Applicant : Jun Koyama et al.  
Serial No. : 10/705,827  
Filed : November 13, 2003  
Page : 2 of 8

Attorney's Docket No.: 12732-176001 / US6730/6731

**Amendments to the Drawings:**

Fig. 9

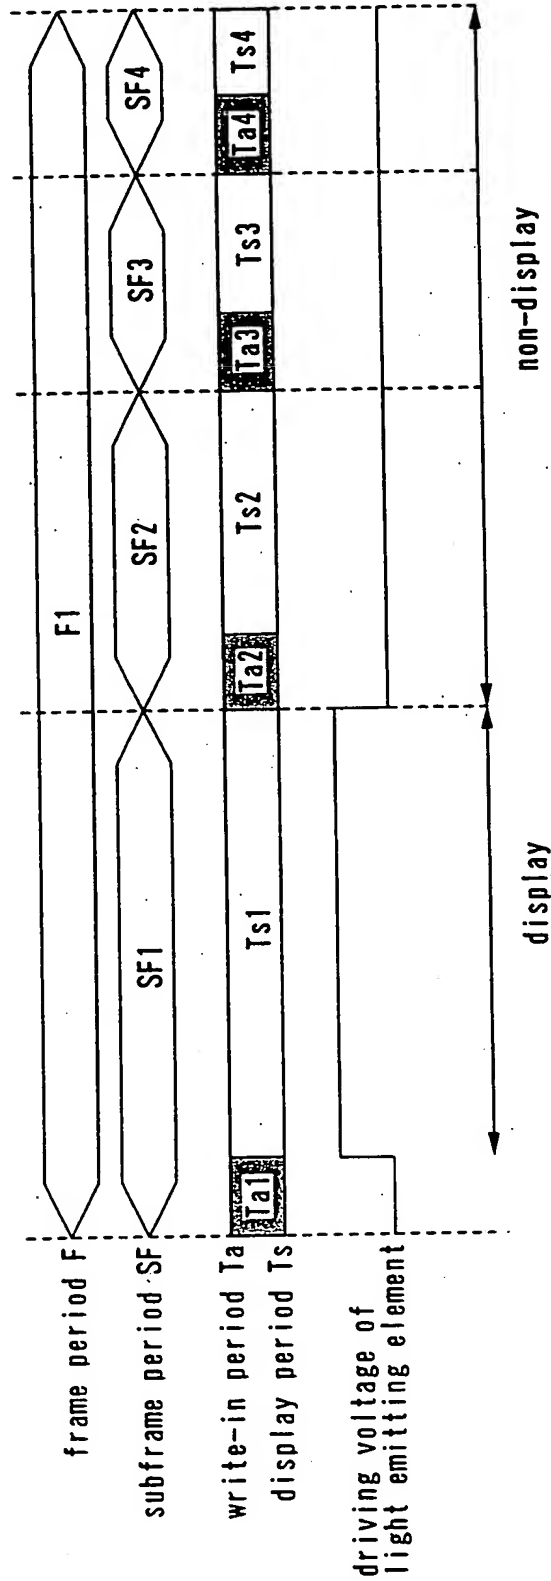
The attached replacement sheets of drawings includes changes to Figs. 9, 13A, 13B and 17 and replaces the original sheet including Figs. 9, 13A, 13B and 17.

Figures 9, 13A, 13B and 17 have been amended to be designated as prior art.

Figures 9, 13A, 13B and 17 were required by the Office action to be designated as prior art. The drawings have been amended in compliance with 37 C.F.R. § 1.121(d). As such, applicant respectfully requests withdrawal of the objection to the drawings.

Prior ART
